SAFETY EVALUATION BY THE OFFICE OF NUCLEAR REACTOR REGULATION

SUPPORTING AMENDMENT NO. 57 TO LICENSE NO. DPR-13

SAN ONOFRE UNIT NO. 1

DOCKET NO. 50-206

FIGURE 1

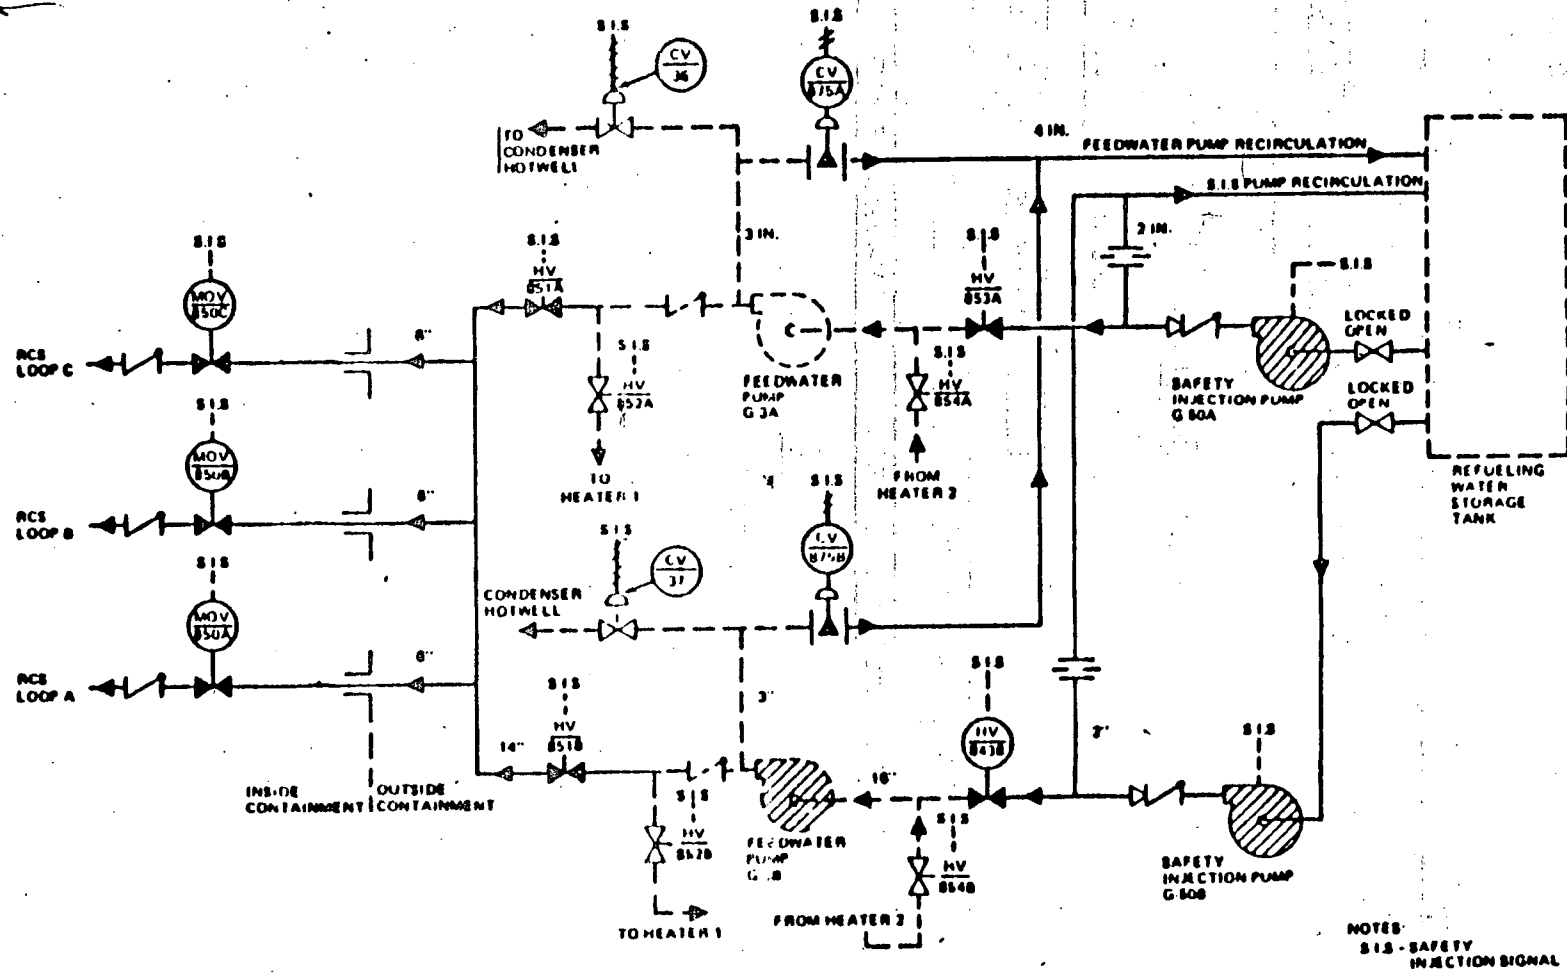
The San Onofre Nuclear Generating Station, Unit 1 (SONGS-1) safety injection system is shown on the attached Figure 1. The design uses the feedwater pumps as safety injection pumps during the injection mode while the pumps designated as "safety injection pumps" in Figure 1 are used as booster pumps.

Figure 1 shows the valve lineup used for normal operation. Condensate from the condenser hotwell is pumped by the condensate booster pump through Heater #2 and HV-854 A&B. Feedwater is then pumped through HV-852 A&B, Heater #1 and on to the steam generators. During normal operation valves MOV-850 A,B&C, HV-851 A&B and HV-853 A&B are closed.

The HV-851 A&B valves have had a one-inch line inserted into the valve body, between the disks, which relieves upstream of the valve (discharge side of the feedwater pump as seen in Figure 1). A normally closed solenoid valve in the pressure relief line will automatically open upon receipt of a safety injection signal. This relief line reduces differential pressure across the upstream disks of HV-851 A&B.

The HV-853 A&B valves have also had a one inch line inserted into the valve body between the disks. This relief line, which is normally open, discharges downstream of the valve (suction side of the feedwater pump as seen on Figure 1). This relief line reduces differential pressure across the downstream disks of HV-853 A&B.

SAFETY INJECTION DELAY TIME (SECONDS)  
FOR MODIFIED SIS

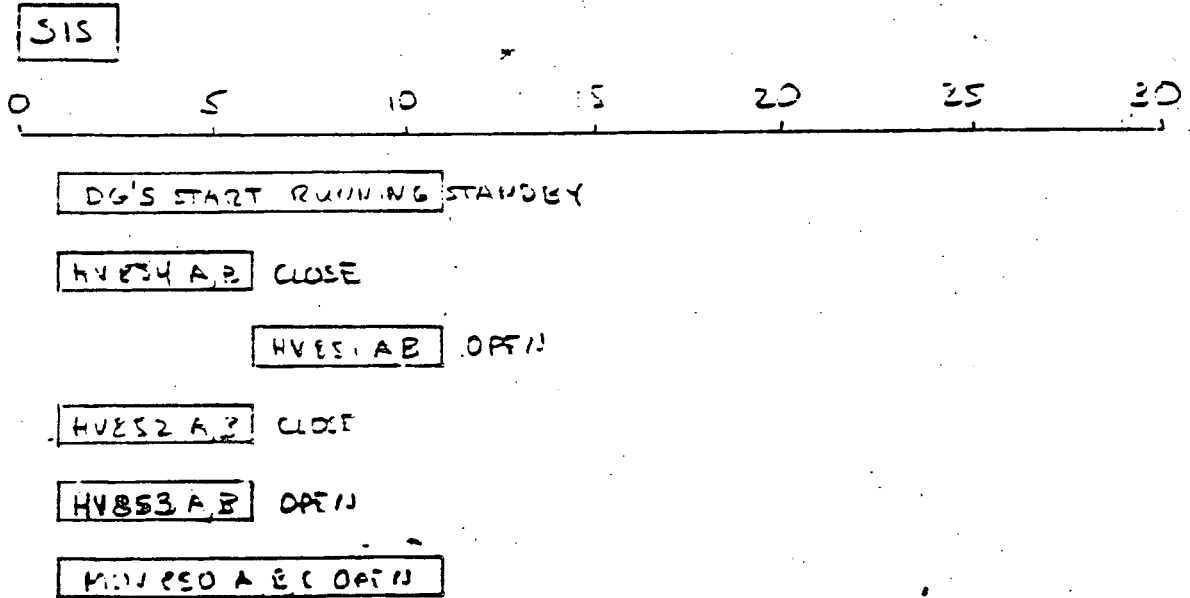
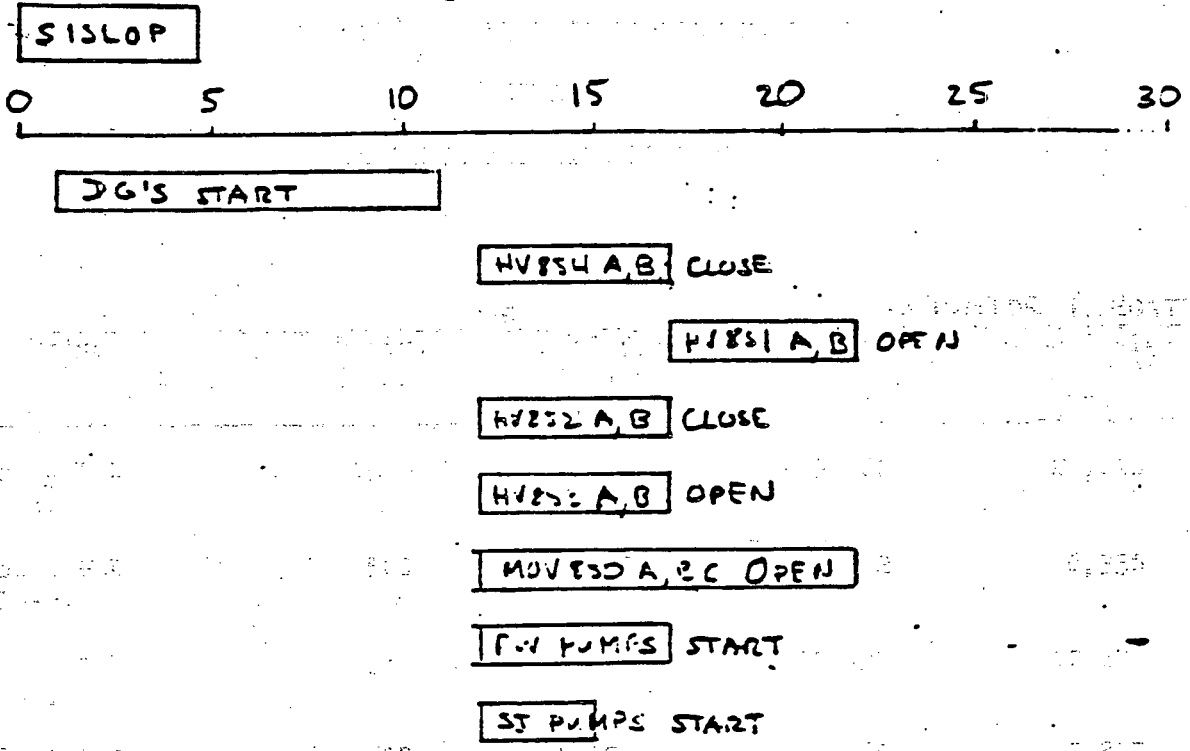
When offsite power is available, the original valve sequencing (Attached Figure 2A) had the MOV-850 A,B&C valves opening immediately following receipt of an SIS.

The attached Figures 2A and 2B show the valve sequencing for both the existing design and the design change respectively.

In the existing design, valve movement is initiated immediately following SIS if off-site power is available and is delayed for 11 seconds for SISLOP. The sequencer connects the diesel generator to the bus at a 10 second step and initiates valve movement at an 11 second step.

The modification makes SIS-only valve sequencing design identical to that of SISLOP.
